## NOVAPLEX JZ19-37

### **NOVAPLEX JZ19-37 WITH REZONING 18.733**

Public hearing at the request of BC Novaplex, LLC for Planning Commission's recommendation to City Council for a Zoning Map amendment from Office Service Technology (OST) to High-Density Multiple Family (RM-2) with a Planned Rezoning Overlay. The subject property is approximately 22 acres and is located on the west side of Haggerty Road, north of Twelve Mile Road (Section 12). The applicant is proposing to develop a 270 unit multiple-family residential development.

## PLANNING REVIEW

TYPICAL CARPORT DETAIL  
NO SCALE

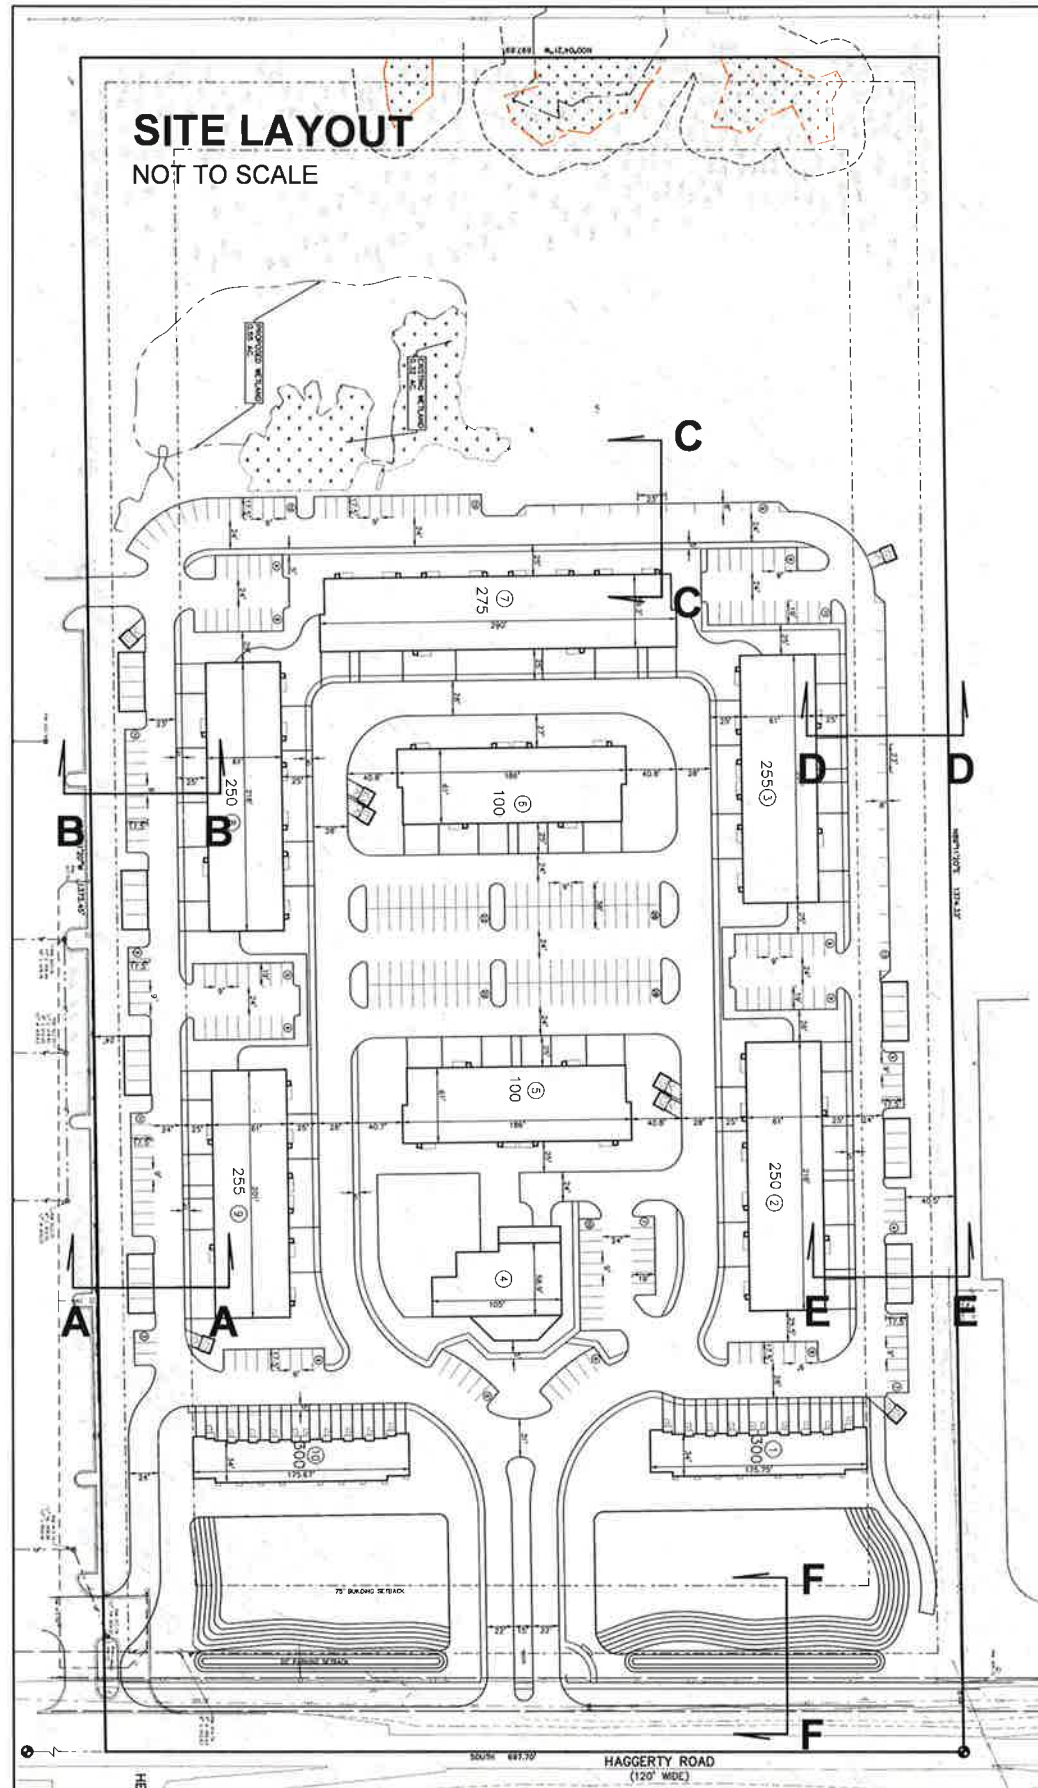
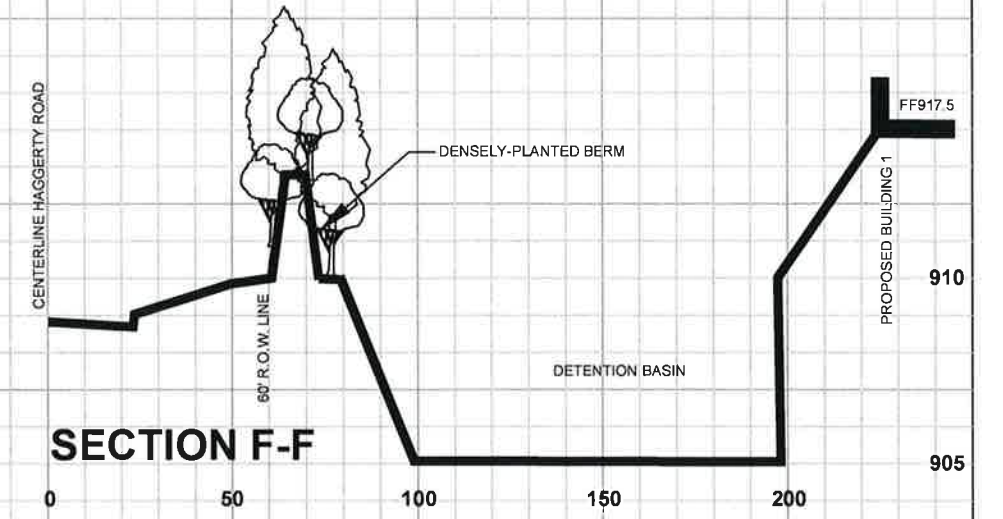
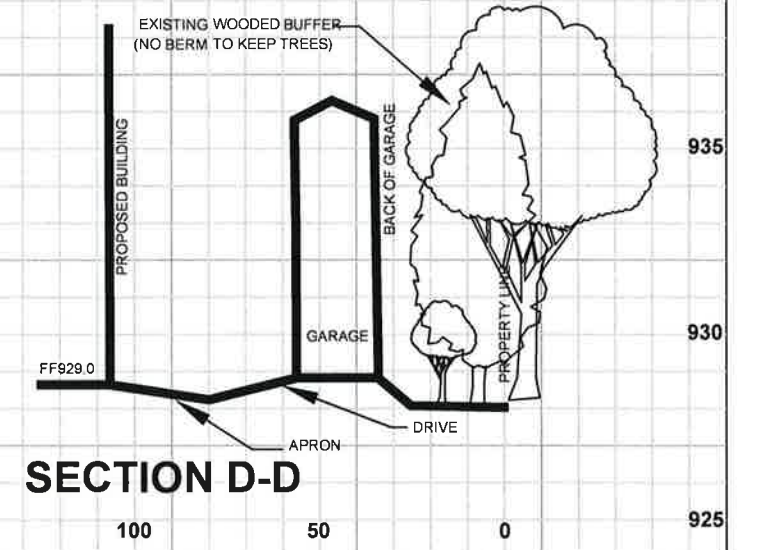
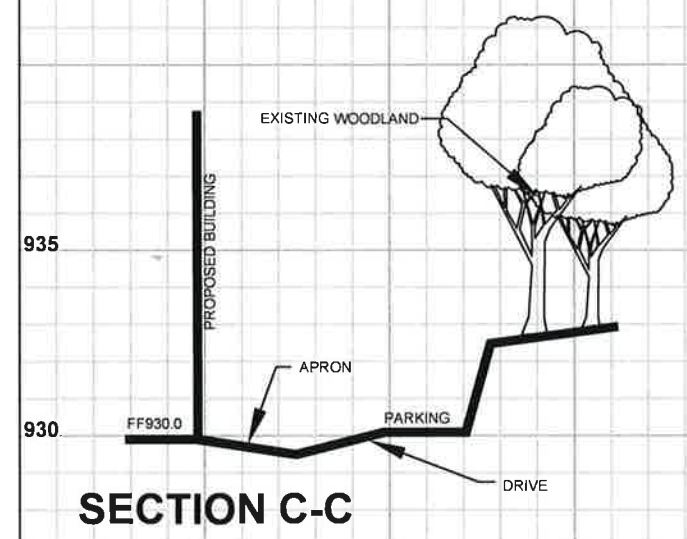
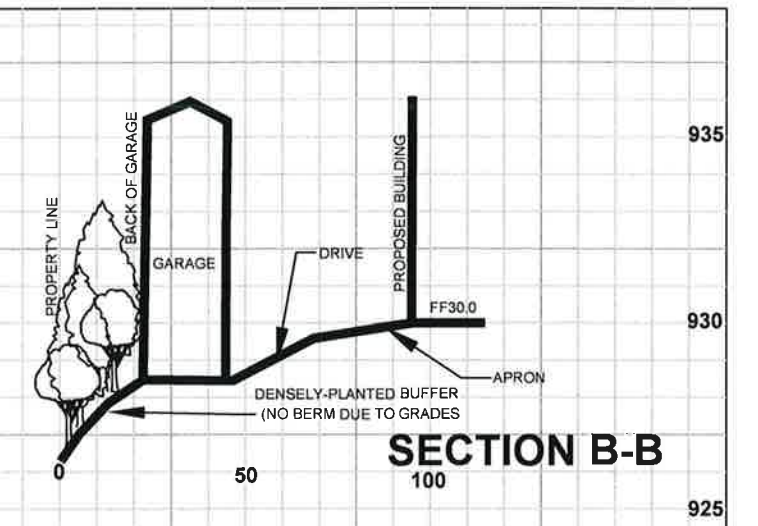
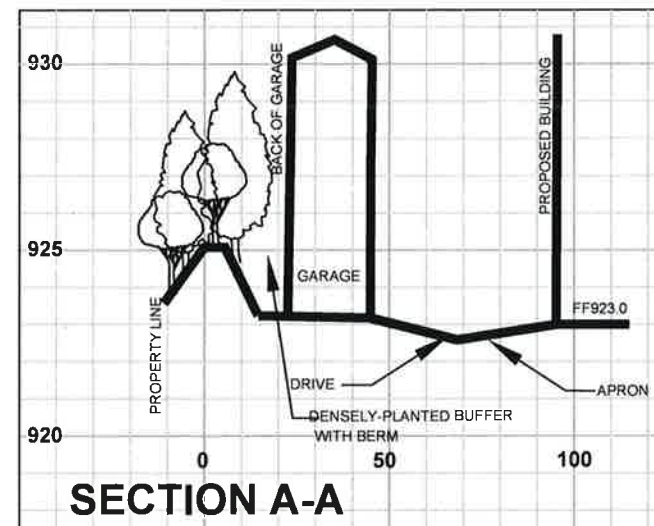
13. Planning deviation from section 4.19.1.J for exceeding the maximum number of accessory buildings for properties more than 21,780 square feet (*a maximum of two are permitted; six garages and 20 carports are proposed*). **[This would be supported if the elevations comply with the Ordinance requirements or acceptable alternatives are proposed, however the carport details provided by the applicant do not comply with the Façade Ordinance.]**

- b) The carports shall be designed to comply with the requirement for 30 percent minimum brick required. **[Staff preferred]**
15. Landscape deviation from 5.5.3.F.ii for deficiency in perimeter canopy trees along west sides of parking lots A and E. **This is not supported by Staff. (The applicant is indicating their response letter that they “will widen the area as much as possible and add the recommended trees, provided it can be done without causing encroachments to the westerly woodland.” It is unclear at this time whether this deviation is needed or a lesser deviation will be needed.)**

**Figure 1.** City of Novi Regulated Wetland & Woodland Map (approximate project boundary shown in red). Regulated Woodland areas are shown in green and Regulated Wetland areas are shown in blue.

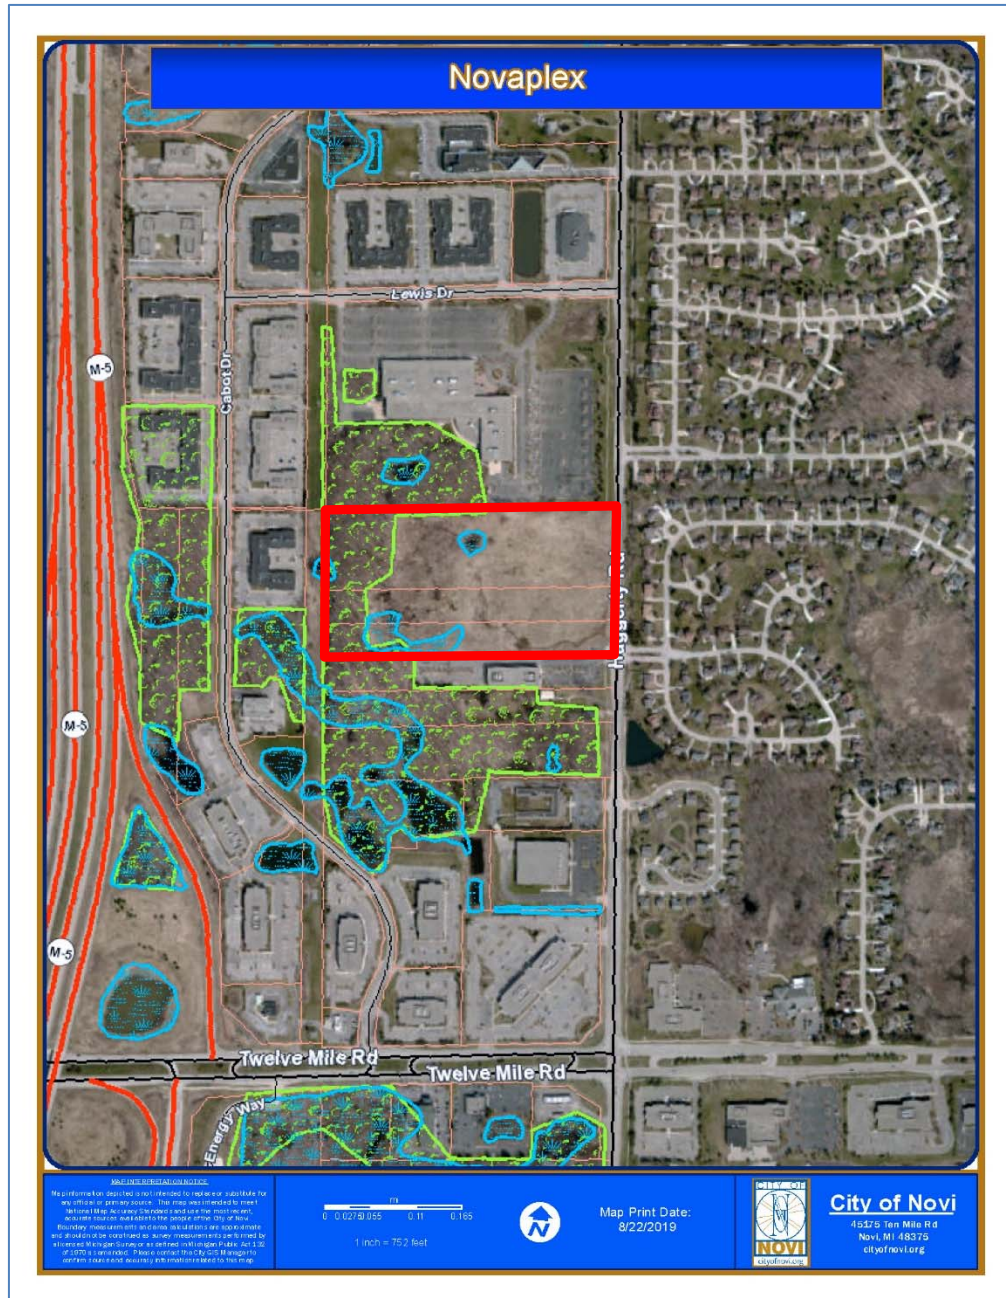
ECT’s in-office review of available materials included the City of Novi Regulated Wetland and Woodland map, USGS topographic quadrangle map, NRCS soils map, USFWS National Wetland Inventory map, and historical aerial photographs. The site includes areas indicated as City-regulated wetland on the official City of Novi Regulated Wetland and Woodland Map (see Figure 1).

Figure 2. Topographic Survey (provided by PEA, Inc.).

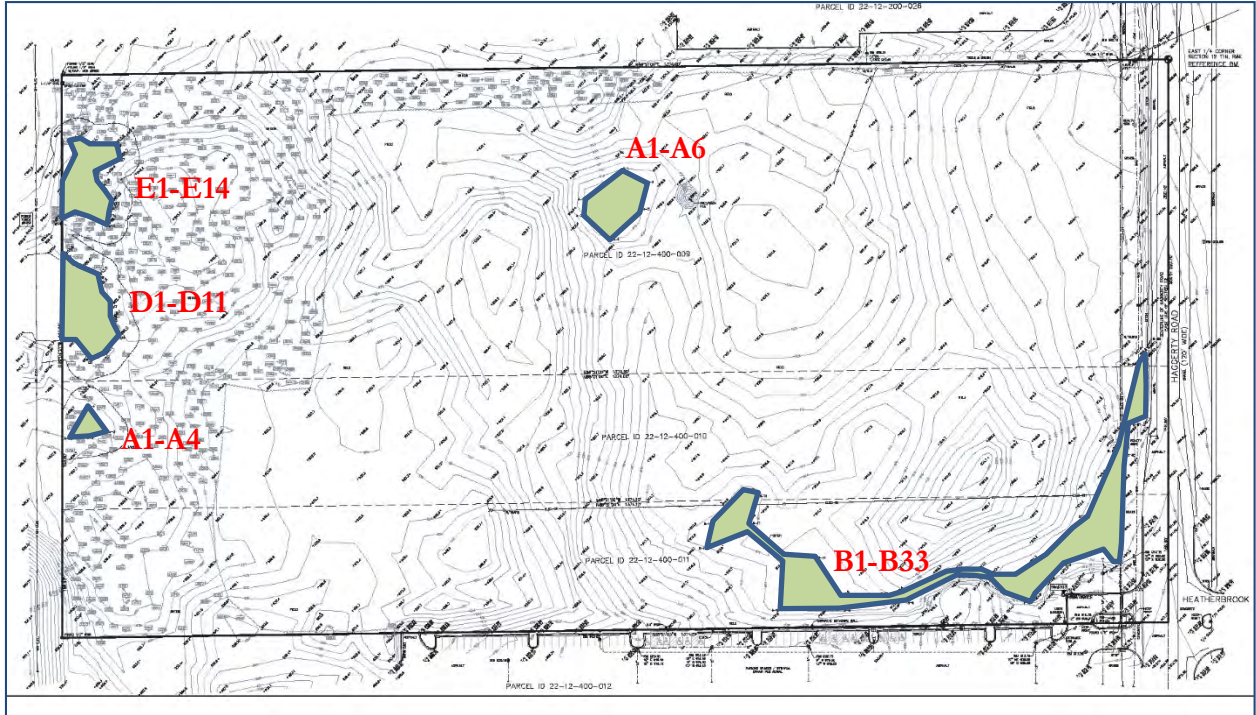
The *Topographic Survey* provided by the applicant (Figure 2) indicates a total of five (5) on-site wetlands. The conceptual site plan that was previously submitted by the applicant proposed the filling of two (2) of the five (5) delineated wetlands on the site. As noted in the *Community Impact Statement (CIS)* prepared July 20, 2017 and previously submitted by the applicant, it is noted that about half of the wetlands are forested with the remaining wetlands consisting of emergent wetlands located in the open field areas. The applicant's consultants (PEA and Fleis & Vandenbrink) note that the wetlands are very typical for urban areas and exhibit poor to fair quality and provide minimal plant diversity. Common plants are noted as silver maple, reed canary grass, cattail, red-twig dogwood and black willow.

As shown on the *Topographic Survey* (Figure 2), a forested buffer remains along the western edge of this parcel. Sections of this remaining forested area appear to exceed 300 lineal feet in width. The remaining woodland areas consists of a high-quality beech-sugar maple forest that has a dense canopy dominated by beech and sugar maple trees with some ash, basswood, oak, elm, black cherry, and walnut. Ironwood is a dominant understory tree along with beech and sugar maple saplings. Shrubs consist of predominantly spicebush with some witch-hazel, viburnum and common elderberry. Ground cover within this woodland includes creeping strawberry-bush, woodbine, Jack-in-the-pulpit, Solomon’s seal, Christmas fern, bloodroot, beech drops, and mayapple.

ORIGINAL ISSUE DATE: AUGUST 18, 2017  
PEA JOB NO: 2015-298  
SCALE: 1" = 50'  
DRAWING NUMBER: L-10.0

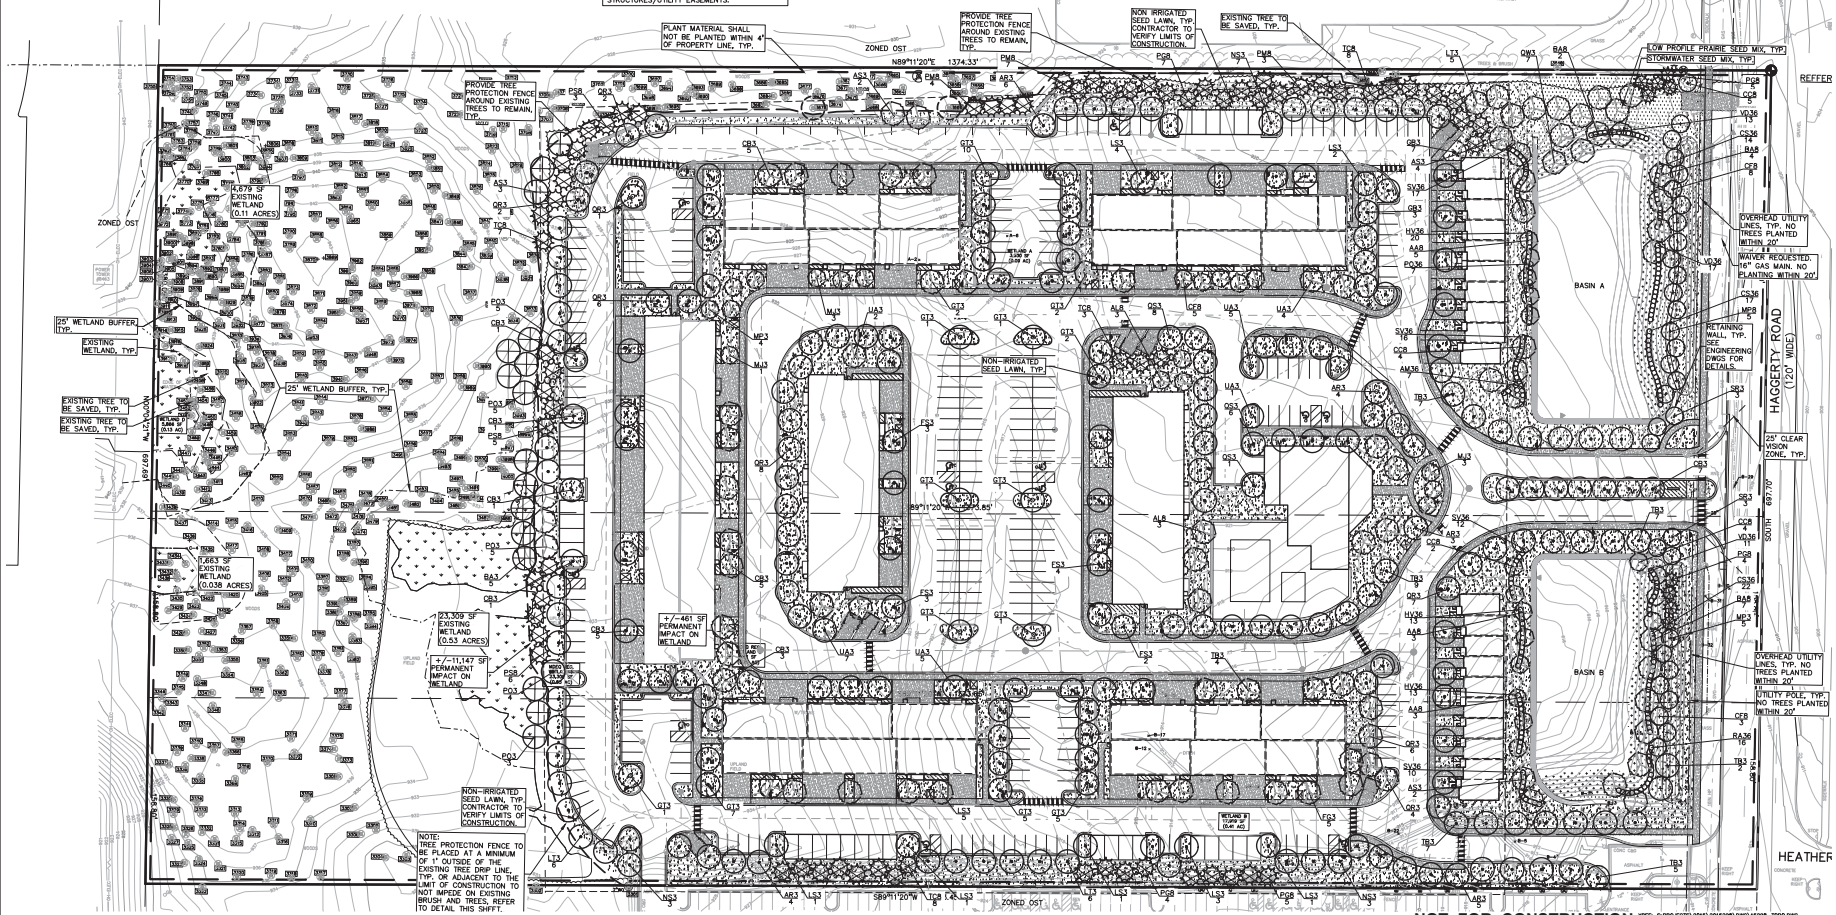
**Please work to eliminate the unsupported deviation and replace the Waivers Requested on Sheet L-1.0 with a list of deviations required.**

6. It should be noted that the *Preliminary Landscape Plan* (Sheet L-1.0) indicates that woodland replacement trees are to be planted within the regulated woodland areas remaining on the west side of the project site. The Plan also notes that replacement planting numbers and locations within the woodland will be jointly determined by the applicant's landscape architect and the City of Novi's Landscape architect. Any trees that cannot be planted without bringing harm to the existing woods will be replaced by a contribution to the City of Novi Tree Fund.
